**ZONING AMENDMENT
& SUBDIVISION STAFF REPORT****Date: January 20, 2011****APPLICANT NAME**

Forest Park Subdivision, Resubdivision of Lot 5 and a Portion of Lot 6

LOCATION1916 Dauphin Island Parkway
(West side of Dauphin Island Parkway, 560'± North of Old Military Road, extending West to Roys Lane)**CITY COUNCIL
DISTRICT**

SITE PLAN

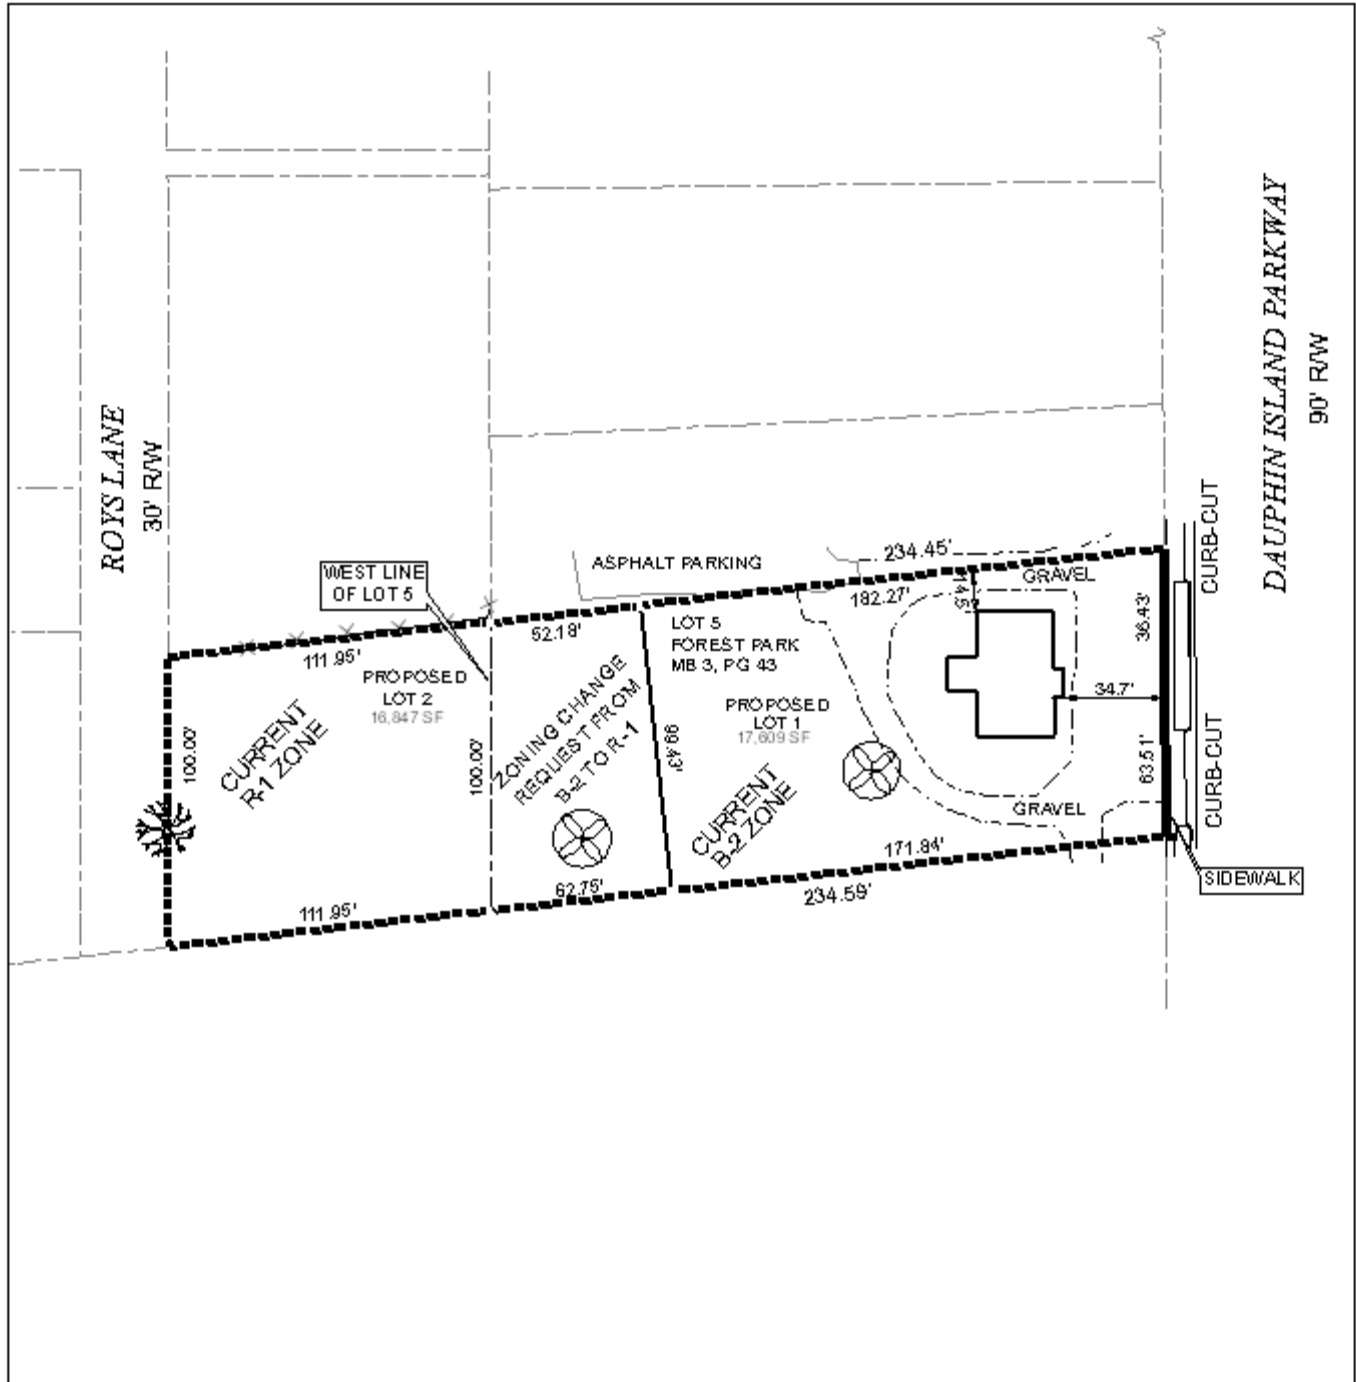
The site fronts onto Dauphin Island Parkway, a major street, and Roys Lane, a minor street. The right-of-way for Dauphin Island Parkway should be 100 feet, according to the Major Street Plan component of the Comprehensive Plan, however, the plat shows that the right-of-way is only 90-feet wide: dedication sufficient to provide 50-feet from centerline should be required. Roys Lane, while a minor street, should have a minimum right-of-way width of 50-feet, however the plat shows that the right-of-way is only 30-feet wide. The Engineering Department has specifically requested the dedication of 10-feet of right-of-way along Roys Lane.

The site has two existing curb-cuts onto Dauphin Island Parkway, however, as the proposed commercial lot will only be 100-feet wide, it is recommended that Lot 1 be limited to one curb-cut, however, the curb-cut reduction should only be implemented at the time that Lot 1 is additionally improved or redeveloped. The size, design and location of any modified curb-cuts for Lot 1 should be approved by Traffic Engineering and ALDOT, and conform to AASHTO standards. Proposed Lot 2, which will be residential, should also be limited to one curb-cut to Roys Lane, however, the size, design and location of any curb-cuts should be approved by Traffic Engineering, and conform to AASHTO standards.

The plat does not depict the 25-foot minimum building setback line, required by Section V.D.9. of the Subdivision Regulations. The setback for Lots 1 and 2 should reflect the required dedications.

Each lot, as proposed, will meet the minimum width and area requirements of the Subdivision Regulations. The plat depicts their size in square feet, and this should remain on the final plat, if approved, adjusted for any required dedication.

- 2) Dedication of right-of-way along Dauphin Island Parkway sufficient to provide 50-feet as measured from the centerline;
- 3) Depiction of the 25-foot minimum building setback line along Dauphin Island Parkway for Lot 1;

- 4) Depiction of a 25-foot minimum building setback for Lot 2 along Roys Lane;
- 5) Placement of a note on the final plat stating that Lot 1 is limited to one (1) curb-cut to Dauphin Island Parkway, with the size, design and location to be approved by Traffic Engineering and ALDOT, and to conform with AASHTO standards, with curb-cut improvements to take place when Lot 1 is additionally improved or redeveloped;

- 6) Placement of a note on the final plat stating that Lot 2 is limited to one (1) curb-cut to Roys Lane, with the size, design and location to be approved by Traffic Engineering, and to conform with AASHTO standards;

- 8) Provision of a buffer between Lots 1 and 2, which complies with Section V.A.8. of the Subdivision Regulations; and
- 9) Revision of the plat to depict the lot size in square feet, after any required dedication.
